# **PR13: ORR consultation on electricity for traction charges for CP5**

## **Network Rail's response**

May 2013

Figure 1 - NR exposure to wash-up in ESTA A (an AC 'money back' ESTA)

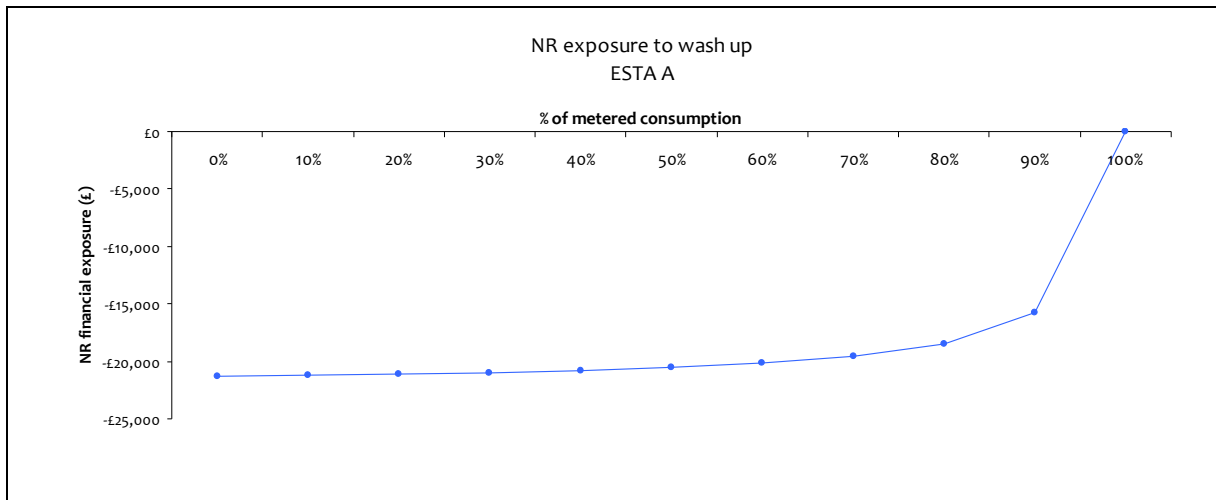
Figures 1 and 2 illustrate Network Rail's financial risk profile in a 'money back' scenario, for ESTA A (AC) and ESTA U (DC), respectively. They show that, as the proportion of metered consumption increases in an ESTA where modelled consumption rates are too high, the amount of financial gain which Network Rail would receive decreases, and hence Network Rail would be financially disincentivised to accommodate additional on-train metering. At around 90% there is a 'step change', where the financial gain quickly reduces to zero.

Figure 3 - NR exposure to wash-up in ESTA B (an AC 'money to pay' ESTA)

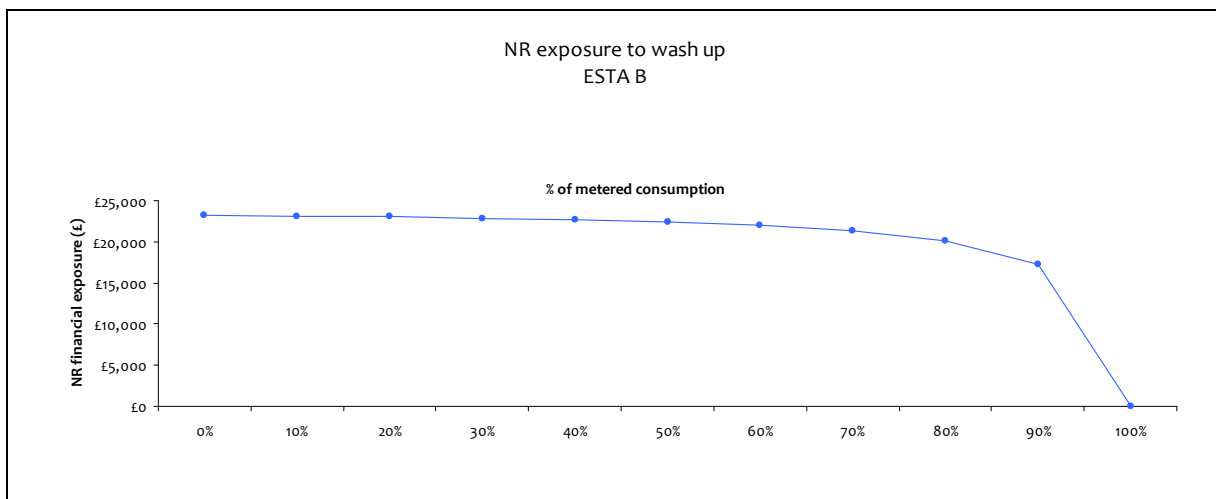
Conversely, Figure 3 shows an AC ESTA (ESTA B) in which the modelled consumption rates are too low, hence operators make a payment to Network Rail through the volume wash-up. In this situation, Network Rail's risk of exposure to the volume wash-up decreases as more on-train metering is accommodated. Similarly, at 90% of metering this quickly reduces to zero. However, in 2011/12 this situation only applied in 2 of the 19 ESTAs.
